August 14, 2023

<u>Re: Rapid Ride J Line – For Equity, relocate redundant J line dollars to South</u> <u>Seattle</u>

Rapid Ride J Street Design Diagram – Eastlake & Lynn

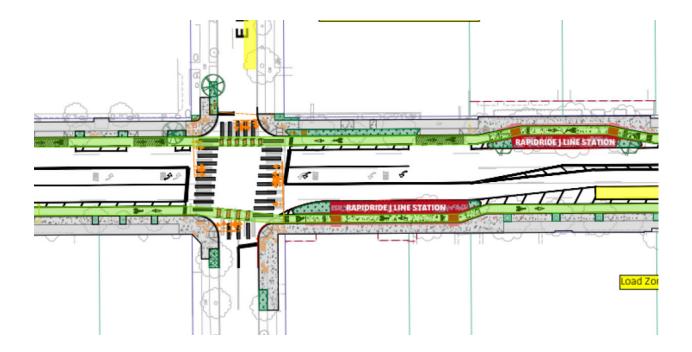
By compromising our pedestrian space, we risk limiting the accessibility and safety of pedestrians, particularly those with mobility challenges or individuals who rely on strollers, wheelchairs, or other mobility aids. In addition, our local businesses rely heavily on pedestrian infrastructure for their success and such a deviation would be a fatal blow to many of our longest-tenured and most-loved businesses in Eastlake.

The following diagram shows SDOT's proposed RR-J design at Eastlake Avenue and Lynn Street, which is effectively the "Main & Main" of the Eastlake Urban Village. The shadowed outlines show where existing curb lines and trees would be removed. Please compare this to the next diagram which shows the City's own recommended design for Urban Village Main Streets. This design accommodates both bike lanes and bus service, while maintaining street trees, adequate sidewalks, seating areas for small business as well as loading and parking in some locations.
